TOWN OF PLAINFIELD DESIGN REVIEW COMMITTEE REPORT

DATE: February 10, 2022

CASE NO.: [DP-22-014](#)

REQUESTED ACTIONS: Architectural and site design approval for two (2) industrial buildings on one 37.04 site zoned I-2: Office/Warehouse Distribution

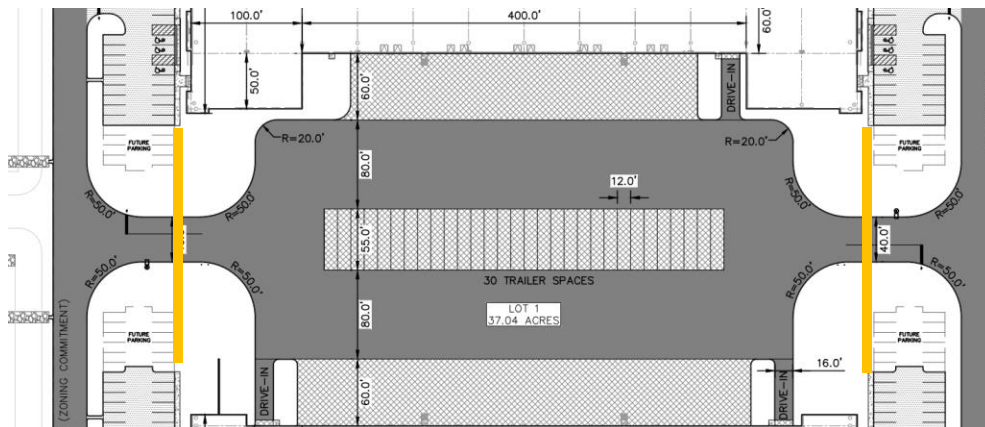
3. **Loading Space Orientation:** (No Loading Spaces shall be permitted to face a Gateway Corridor or other Street where a Residential District exists on the opposite side of said Street.)

The petitioner has requested a Loading Space Orientation Development Incentive to allow docks facing Station Blvd.

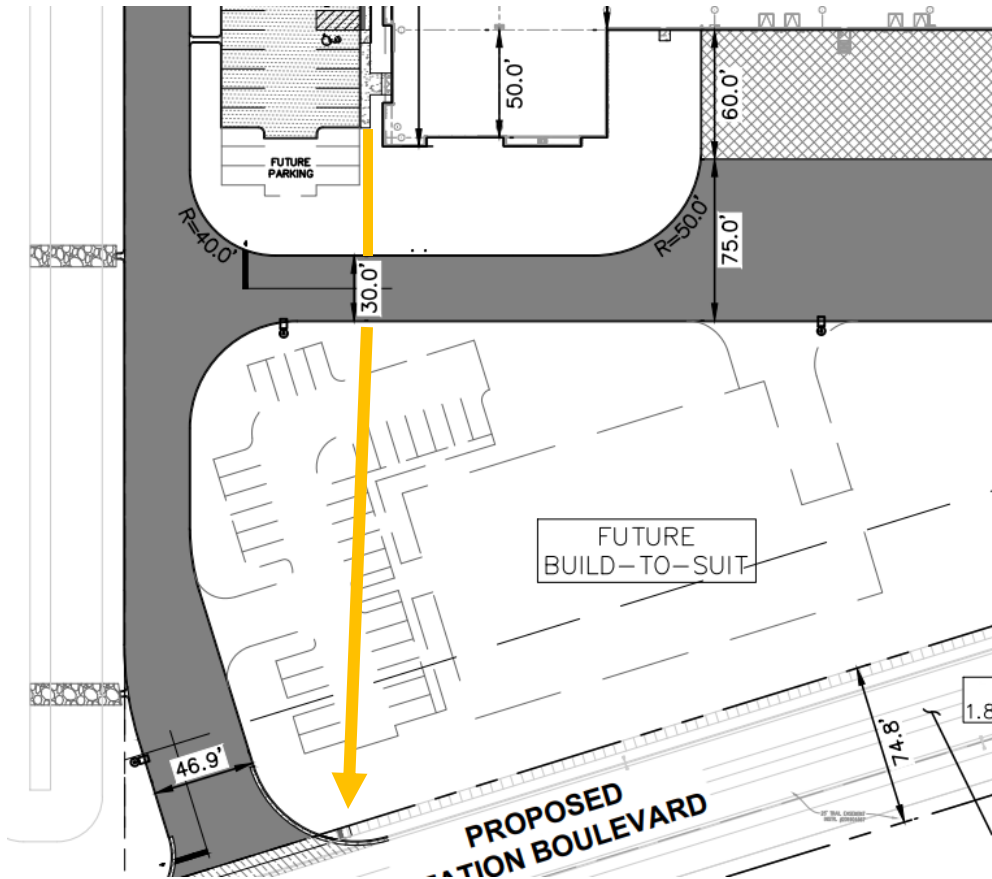
A sidewalk connection is shown to the southeast entrance of Building 2 only. Does not comply. Applicant has agreed to extend sidewalks per the markup below to provide pedestrian connectivity on both sides of both buildings.

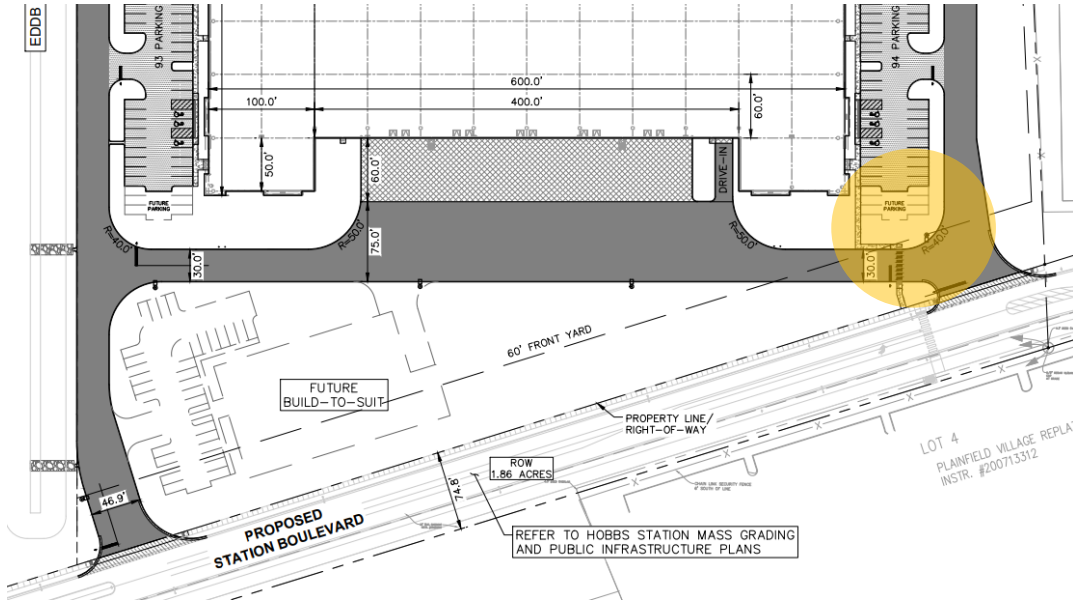
2. The petitioner has requested a Development Incentive to allow loading spaces for semi-trucks to face the front of the property. While the petitioner has provided the additional 4.0 Plant Unit Value needed to allow the incentive, staff would note that the loading space orientation will impact access and circulation on the property – particularly at the eastern drive. While the Town’s Director of Transportation will review site access, his primary focus will be on how the

plan impacts the right-of-way whereas Planning Staff and the DRC are tasked with reviewing the project's site circulation. Does the committee support the Development Incentive to allow the loading space orientation?
